Urban Design Peer Review Report

Forestway Shopping Centre

22 Forest Way, Frenchs Forest NSW 2086

31 October 2024

Source: Proposed GA Plan Ground Floor, 11993_DA-115, 24/09/2021, Nettleton Tribe

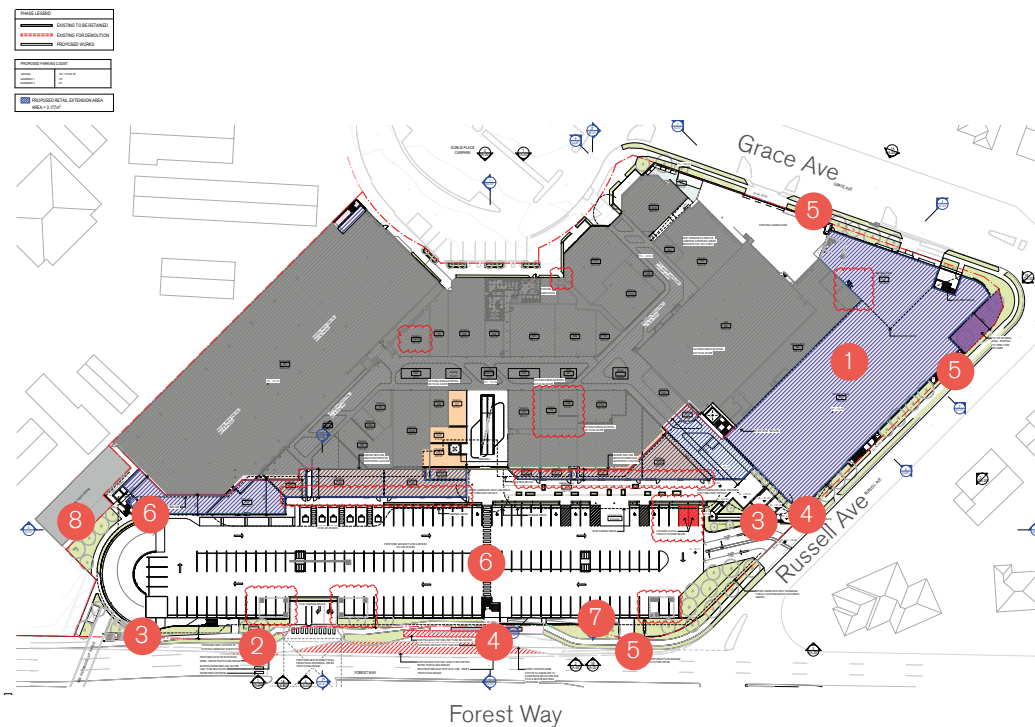
1. Respond to the bushland character, improve the visual connections inside and out to allow the building to sit harmoniously within its surroundings
2. Improve pedestrian amenity and create clear circulation and intuitive wayfinding
3. Reduce congestion and crossover of bicycle, pedestrian and vehicles
4. Make entry points more legible
5. Review setbacks of built form, integration of fire stairs and presentation of pedestrian footpaths
6. Consider increased planting and presentation of pedestrian pathways in carpark
7. Reconsider location of accessible ramp to be more direct
8. Consider impact and access to neighbouring property
